GOVERNMENT OF WEST BENGAL  
IRRIGATION & WATERWAYS DIRECTORATE  
OFFICE OF THE EXECUTIVE ENGINEER  
MALDA IRRIGATION DIVISION  
GREEN PARK, MALDA  
e-Mail ID – maldairrigation@gmail.com

**1<sup>st</sup> ADDENDA/CORRIGENDUM FOR EXPRESSION OF INTEREST{EOI}**  
**No: - WBIW/EE/MID/EOI-01/2025-26**

Name of the Work - **Erosion Abatement in Ganga and Kosi Rivers using Geosynthetic Concrete Mattress or equivalent for Slope Protection and Articulated Concrete Block or equivalent for Toe Protection and Apron at Bhutni Diara under Ratua-I block of Malda district.**

**TYPICAL CROSS SECTION OF RIVER BANK PROTECTION**

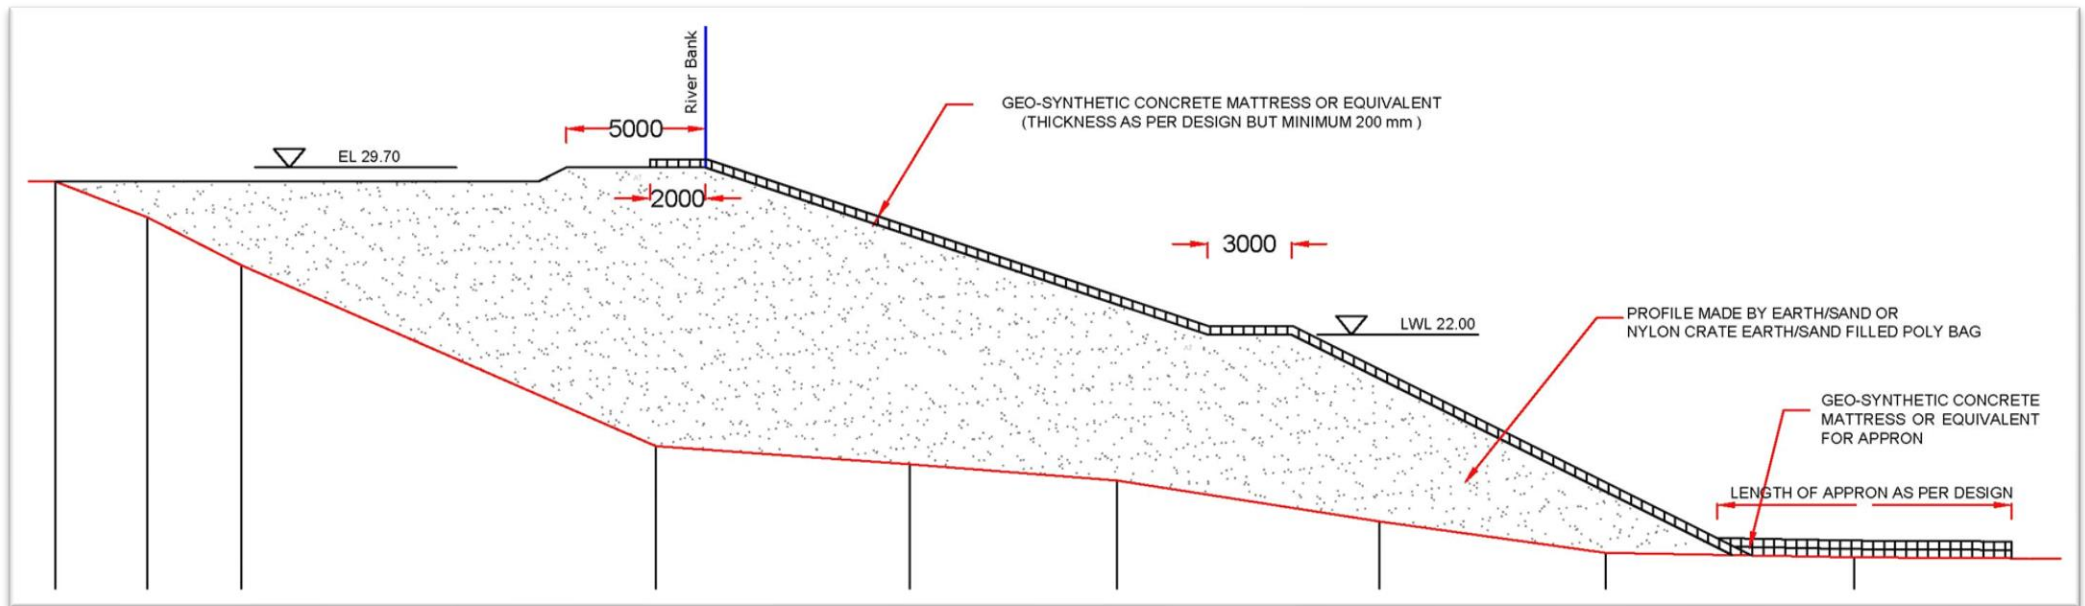
4. Some modification has been made to the '**ANNEXURE -I (SCHEDULE OF ITEM)**' and '**ANNEXURE-III (DRAWING)**', bidders are requested to submit the modified ones annexed with this addenda /corrigendum.
